## **AIRWORTHINESS DIRECTIVE**

Ref. No. 2019-FATA-01020A-06

Applicability – RRJ-95 aircraft

In the course of implementation of AD Nos. 2019-322-03 and 2019-322-05 on RRJ-95 A/C fleet (hereinafter – A/C) cracks on inner ring of a bearing of link of track of a slat section 1 have been revealed. In order to timely detect and eliminate the identified non-conformity as regards to link of track of a slat section

Fig.1

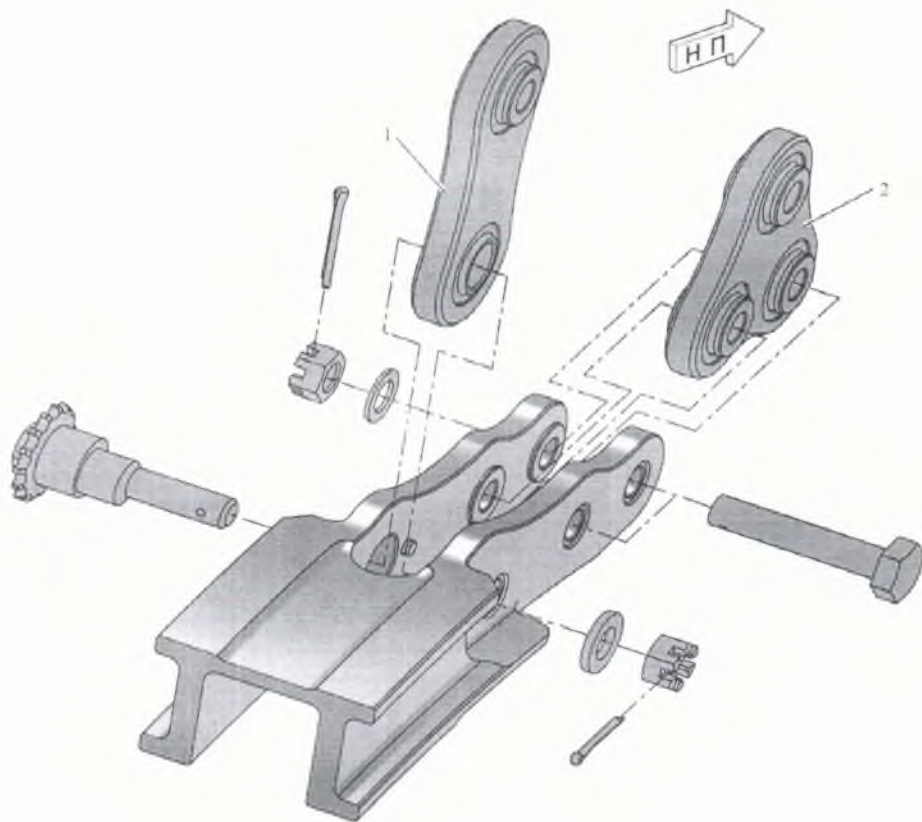
1. During the weekly WY-Check/8 DY on RRJ-95 A/C MSN 95030, 95037 and 95116-95220 to perform inspections of links of tracks (See Fig.1 (items1,2) and Fig.2 (item 3) and bearings of links of tracks of sections 2, 3 and 4 of a slat of LH and RH outer wing in accordance with provisions of p. 4. Б. (2) and (6) of AMM Tasks Nos. 57-43-00-220-802, 57-44-00-220-802 and 57-45-00-220-802 until the implementation of SB No. RRJ-57-00451-BD “Wing – Replacement of link of track of a slat section”.

3. In case of finding a crack of link of track and/or destruction and/or press-out of the bearing of link of track of sections 1, 2, 3 and 4 of a slat of LH and RH outer wing following the results of implementation of p.1 and 2 of this AD – to replace the damaged track link assembly (link of track and bearing):

- For slat sections 2,3 and 4 – to replace with the configuration of link of track of sections 2, 3 and 4 of a slat IAW identification information in Table 1 and IAW AMM Tasks Nos. 57-43-00-900-804, 57-44-00-900-804 and 57-45-00-900-804.

Fig.3

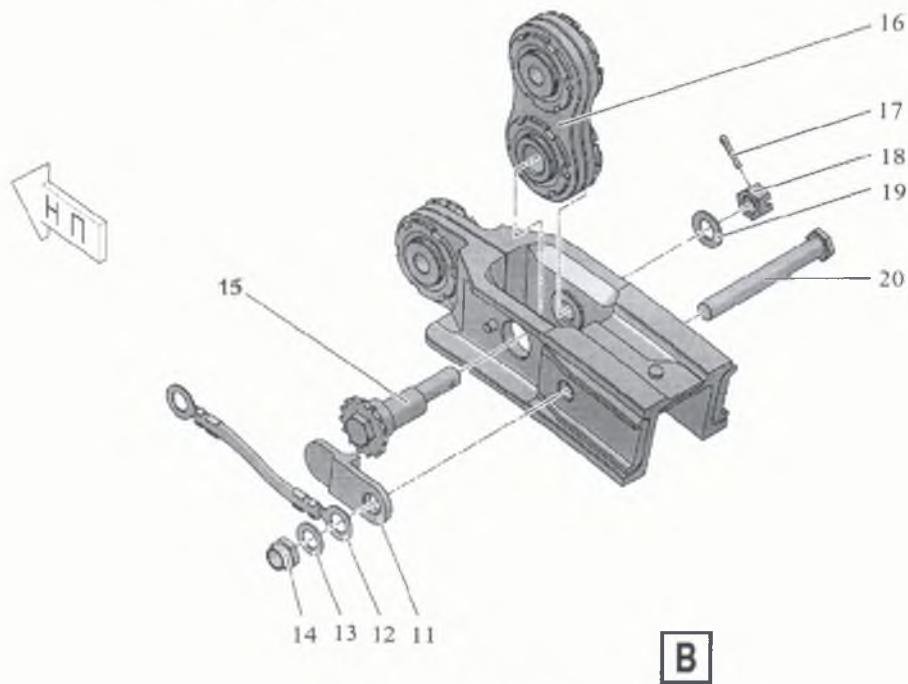
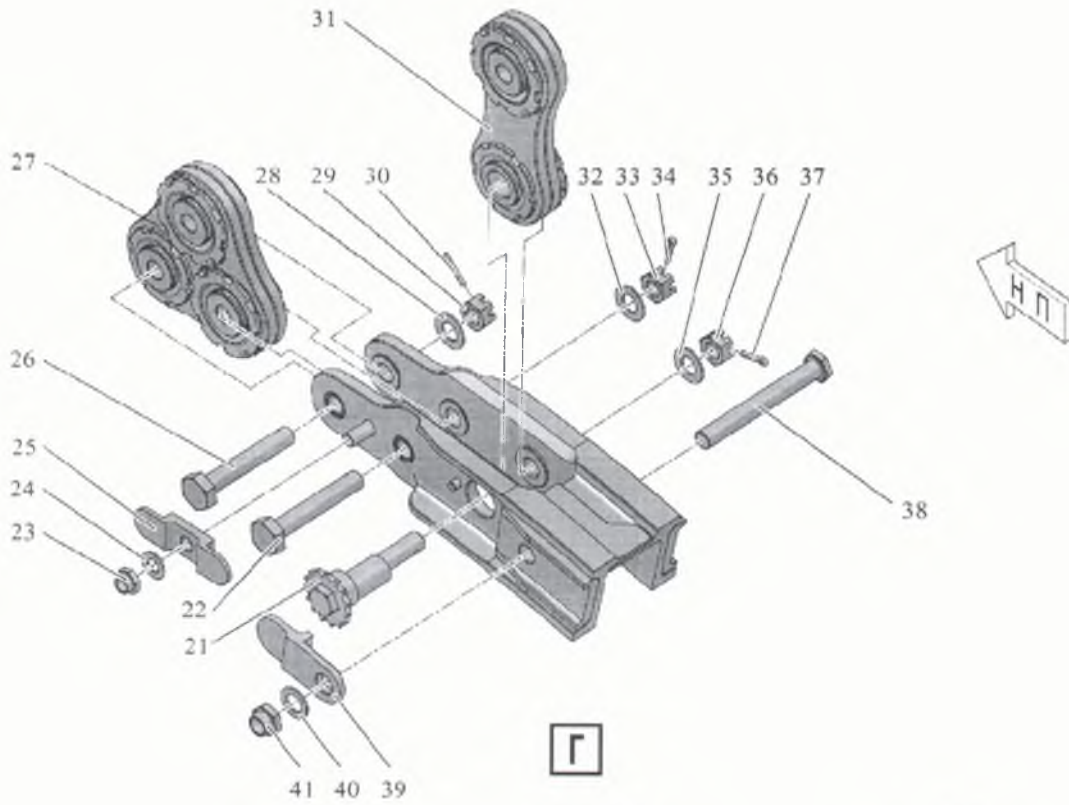
2. During the weekly WY-Check/8 DY on RRJ-95 A/C MSN 95007-95220 to perform one-time inspection of links of tracks (See Fig.3 (items16, 27 and 31) and bearings of links of tracks of section 1 of a slat of LH and RH outer wing in accordance with provisions of p. 4. Б. (2) and (6) of AMM Tasks Nos. 57-42-00-220-802.

- For slat section 1 – to replace with the current configuration of link of track of section 1 of a slat, IAW AMM Task No. 57-42-00-900-804.
